Henderson Response to DRMS TR-32 Geotech Review Report

RE: Climax Molybdenum Company, Henderson Mill, Permit No. M-1977-342, Technical Revision 32, Response to DRMS Geotechnical Stability Analysis Report

Subject: Response to DRMS comments for 3 Dam Buttress Stage II Design,
Henderson Mill Tailings Dam, near Parshall, Colorado

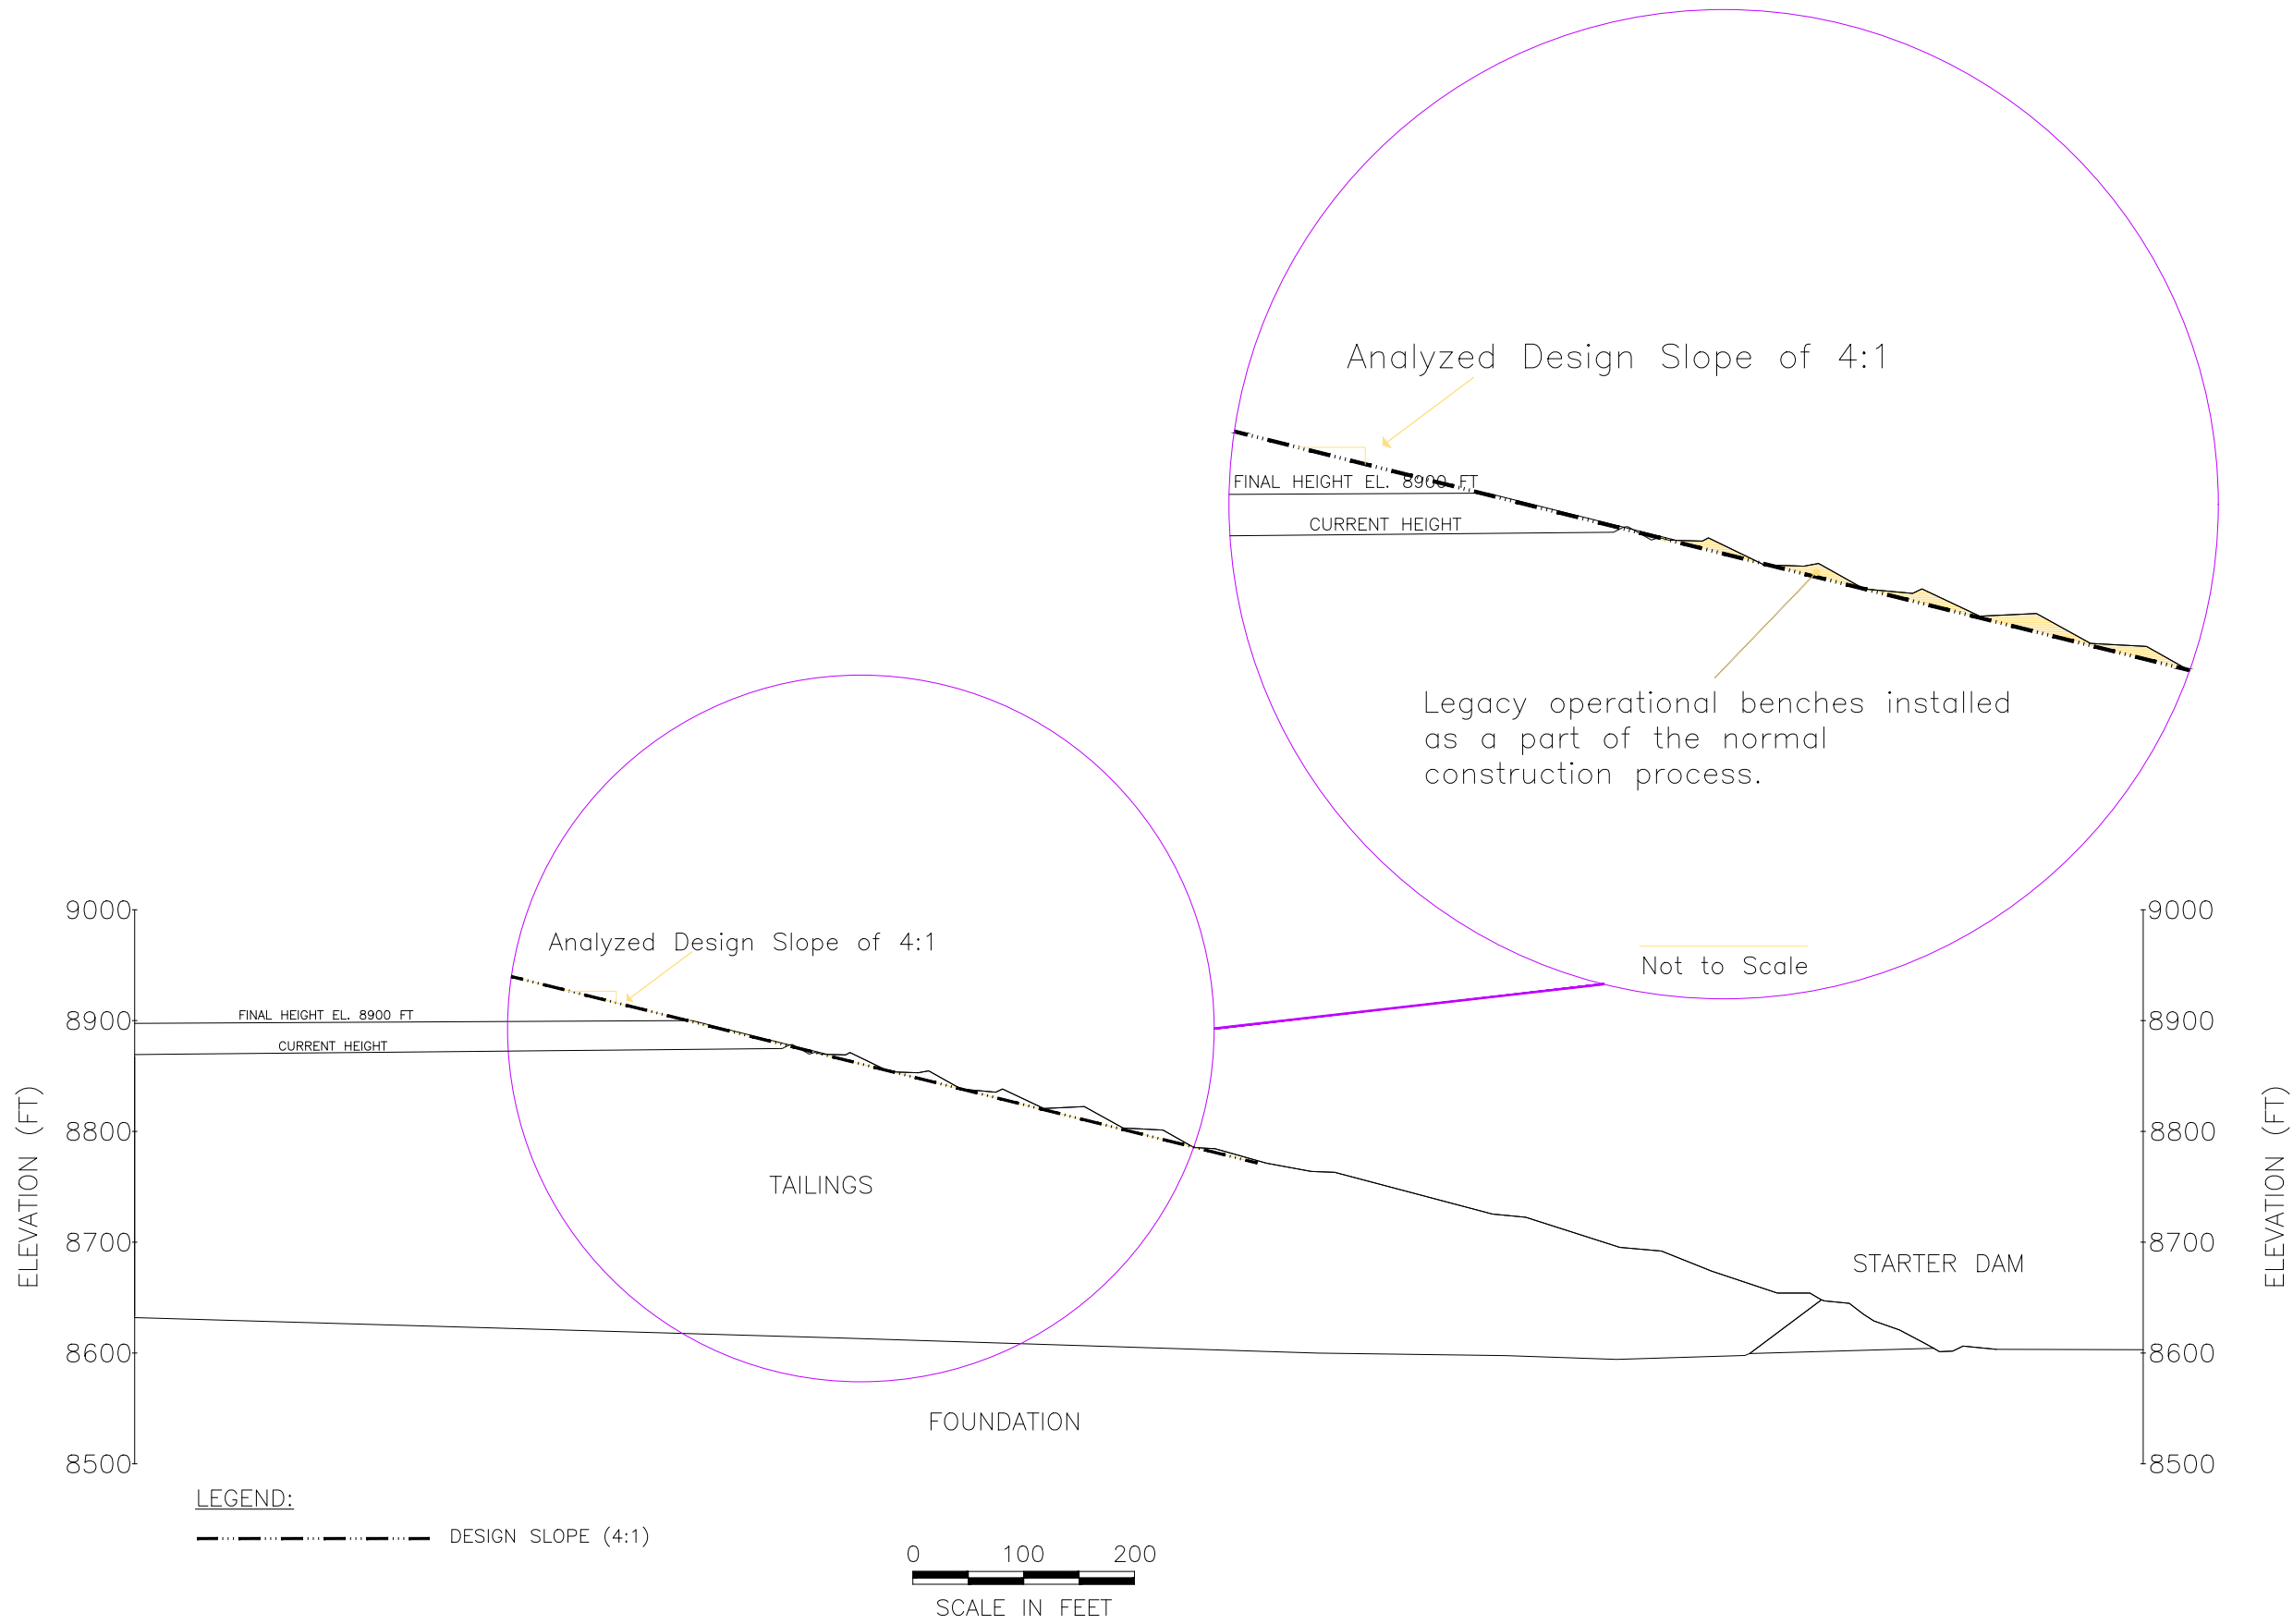
Please have Henderson provide the additional stability analysis for the 1 Dam to ensure to the Division that long-term stability will remain if material is borrowed from the 1 Dam benches.

There was a similar question posed during the review of the Phase I Buttress. The response provided below is excerpted from the 2018 TR-29 adequacy review response since it still applies. The original stability design of 1 Dam was based on an overall design slope of

4:1(horizontal to vertical). Steeper benches are constructed as part of normal operations as the impoundment steps upstream. These benches serve as access routes during operation until the following upstream step is constructed. A schematic showing the design slope and benches is provided in Figure 1. These benches are regularly graded as part of erosion and storm water control measures and are considered standard maintenance of the impoundment. The overall slope of 4:1 provides embankment stability and this slope is maintained during any bench regrading activities.

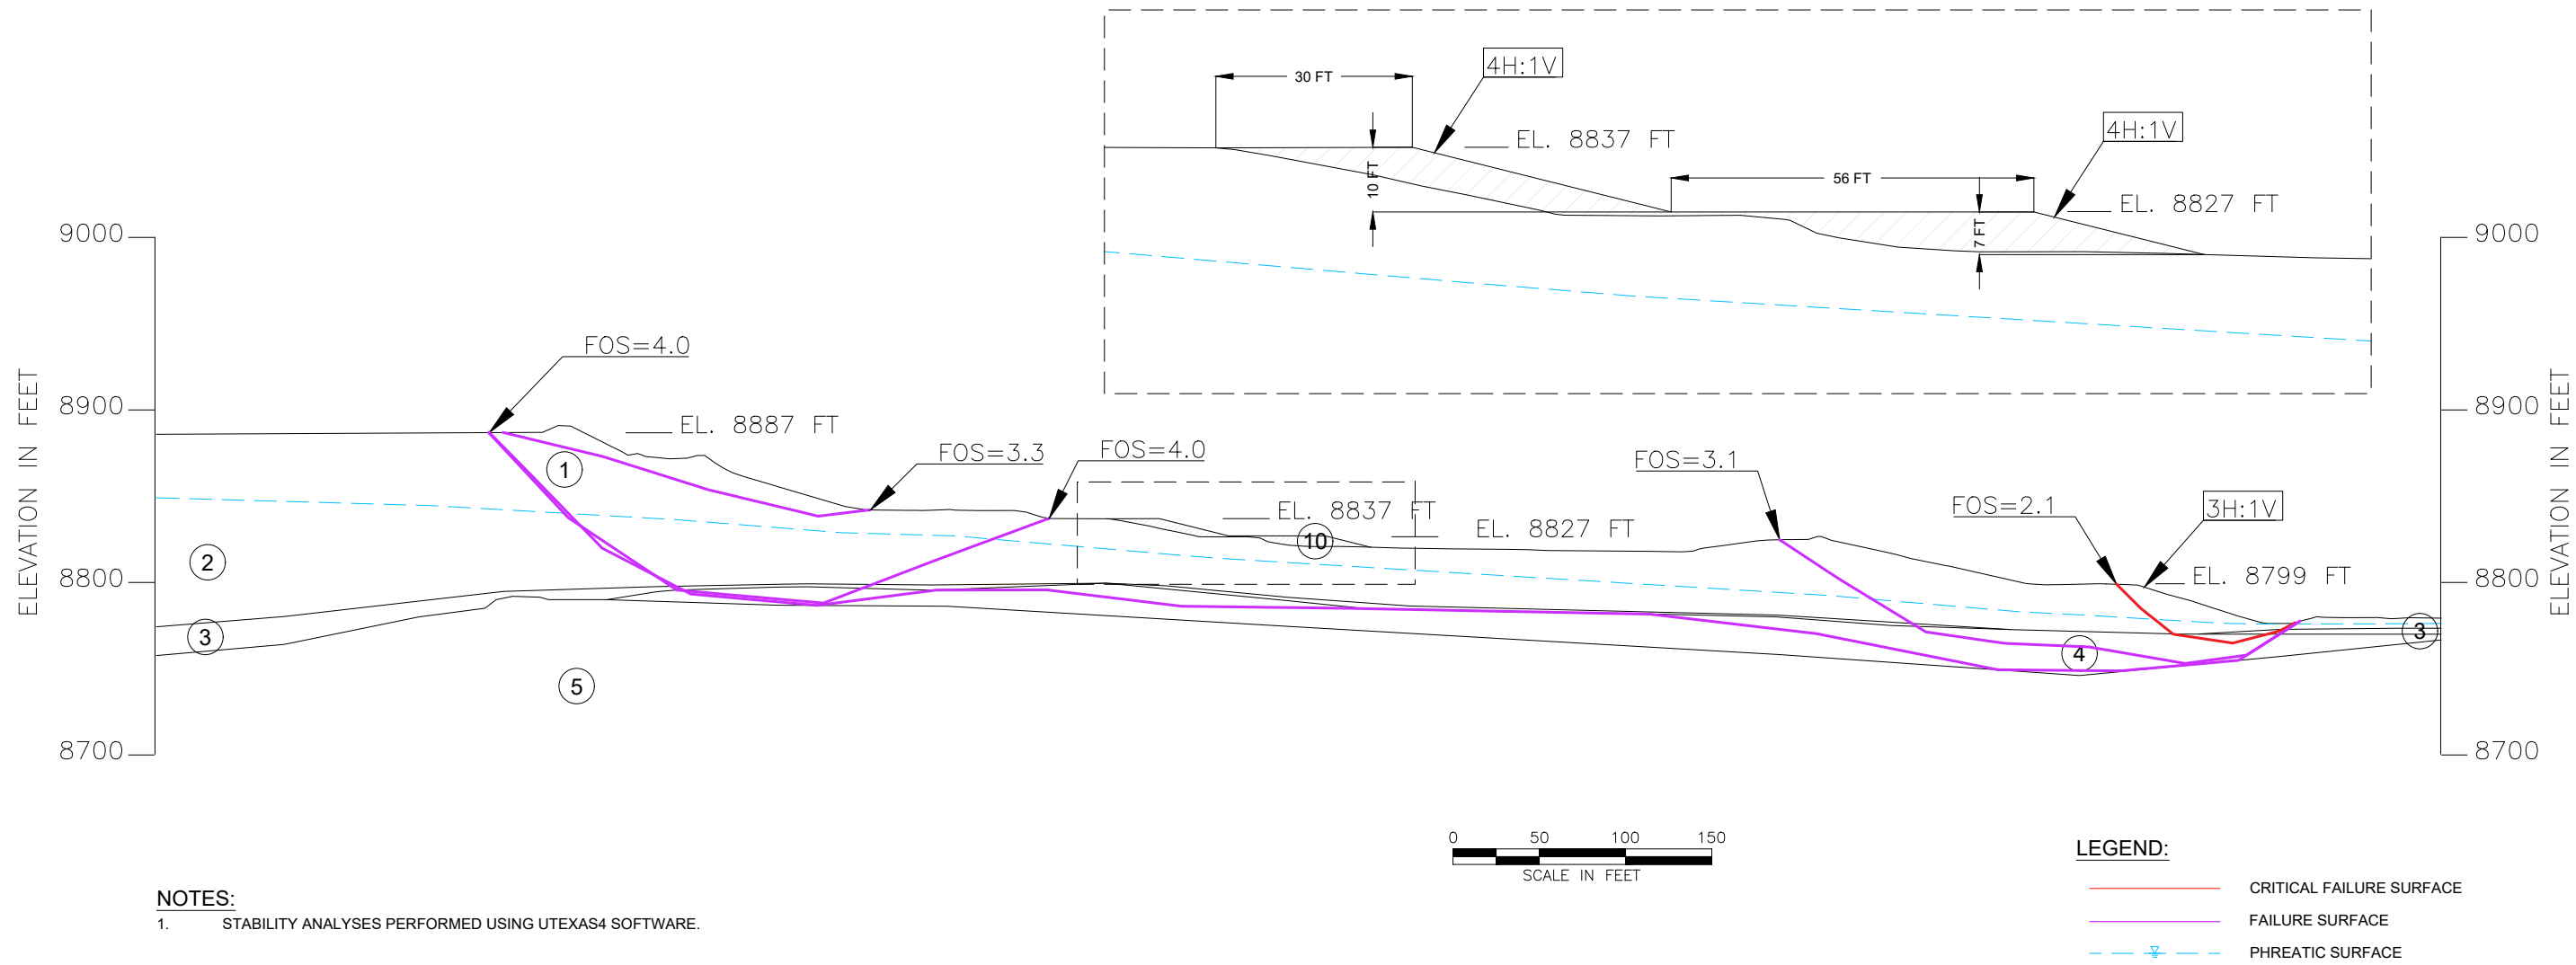
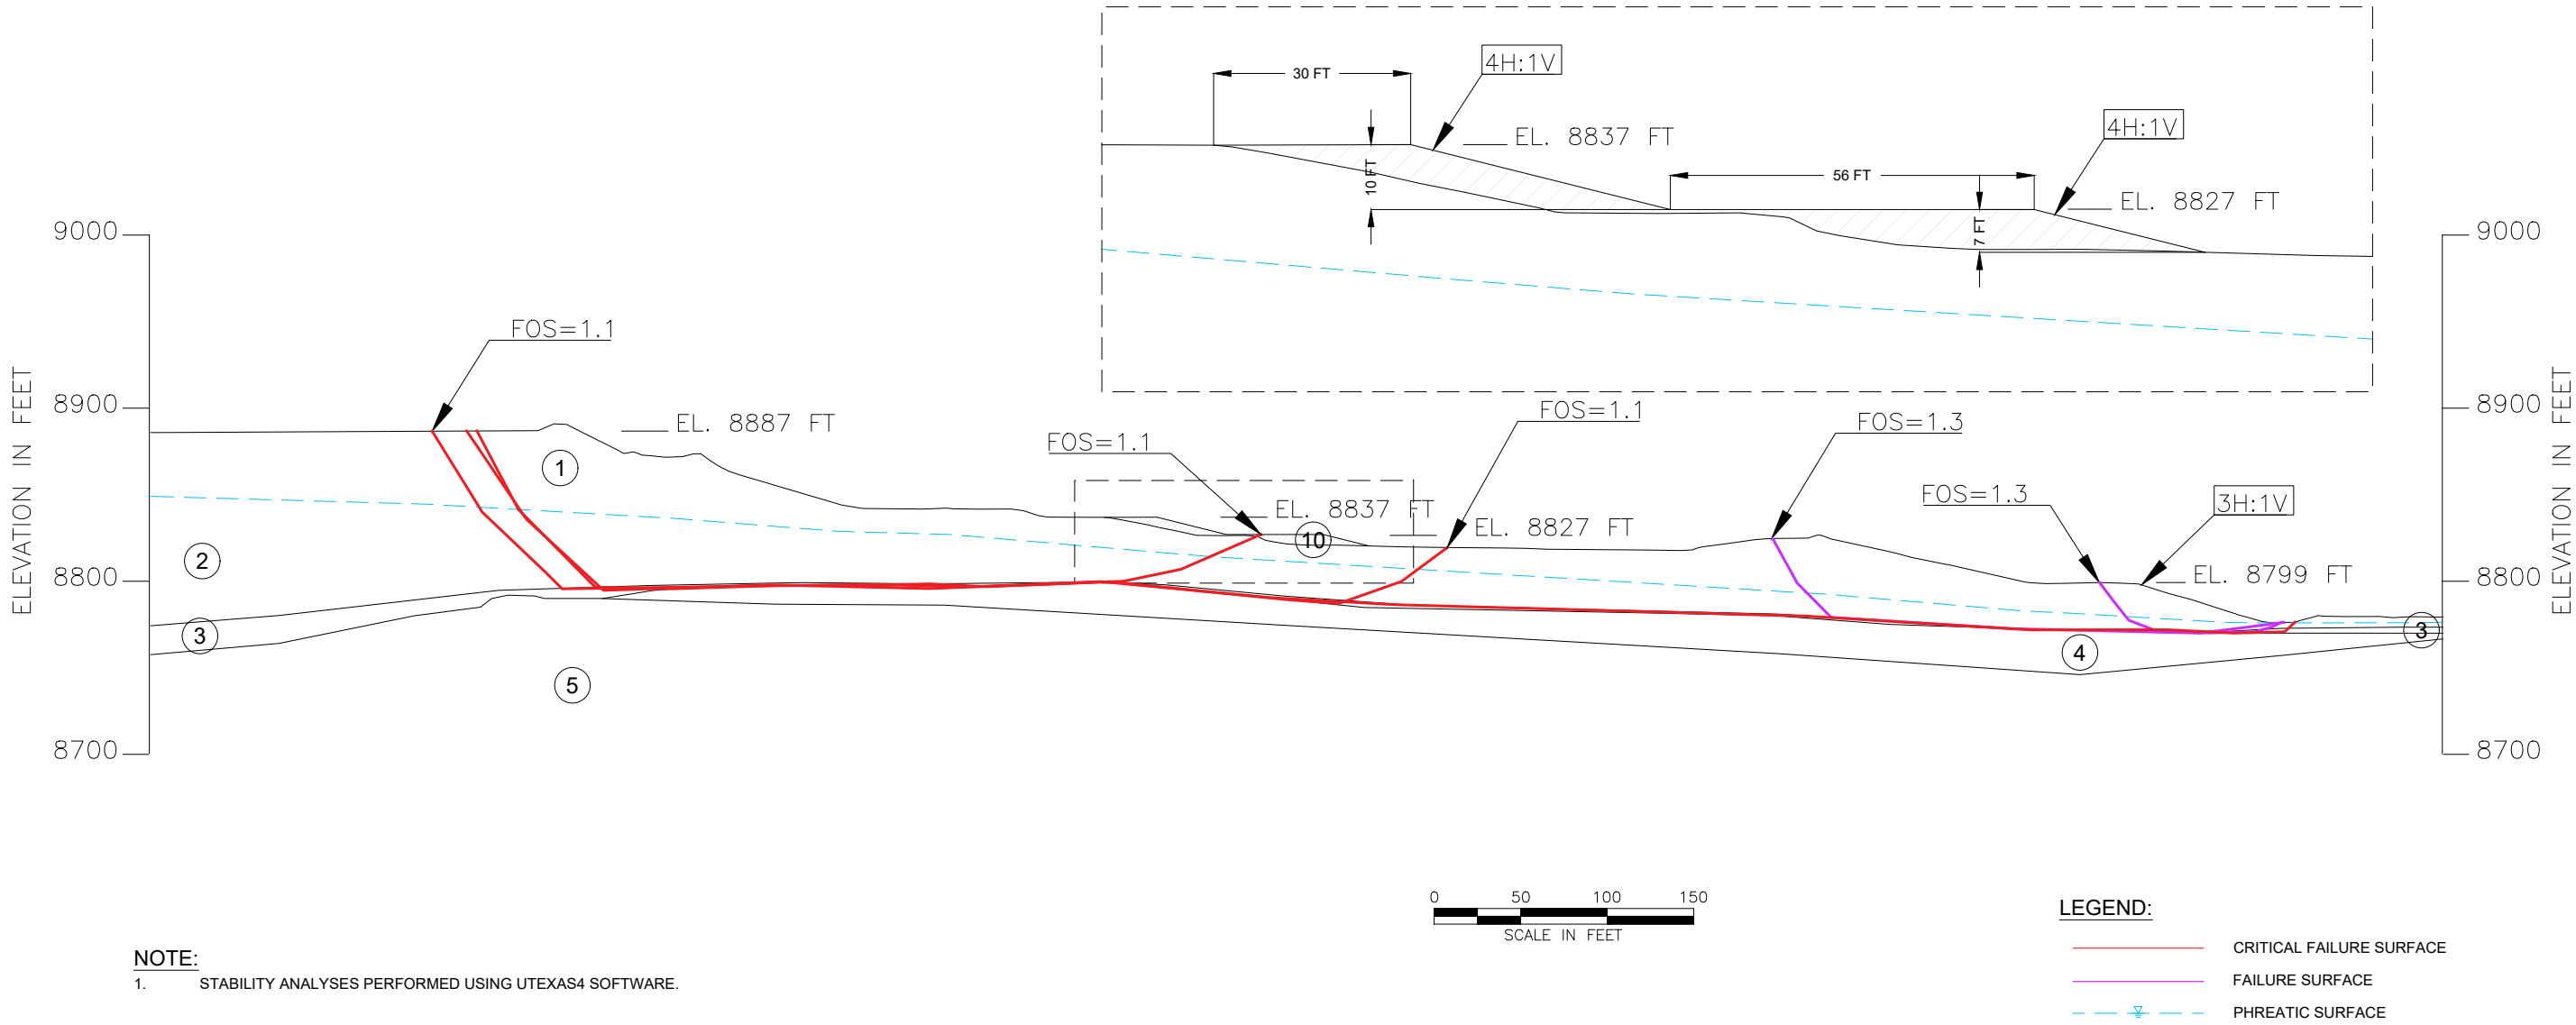
Please provide additional discussion and stability results for the 3 Dam Phase II buttress design under static conditions to ensure a minimum factor of safety of 1.5 is met as stated under Section 30.

Steady-state drained loading conditions represents the long-term stability of the dam. Stability analyses were performed on the design section, Sections 2 and 4A, with the designed Phase II buttress and crest elevation of 8,887 ft under steady-state (static) loading conditions using the drained shear strengths shown on Figures 2 and 3. The limit equilibrium computer program UTEXAS4 (Wright, 2008) and Spencer's method of slices were used for the stability analyses. Spencer's method satisfies all conditions of static equilibrium, including horizontal and vertical force imbalance and moment imbalance. Search routines available within UTEXAS4 were used for circular and noncircular trial shear surfaces to locate critical shear surfaces. The results of the two-dimensional (2D) limit equilibrium steady state drained factor of safety for Section 2 is 2.5 and for Section 4A is 2.1. Figures 2 and 3 show resulting failure surfaces for Section 2 and 4A, respectively.
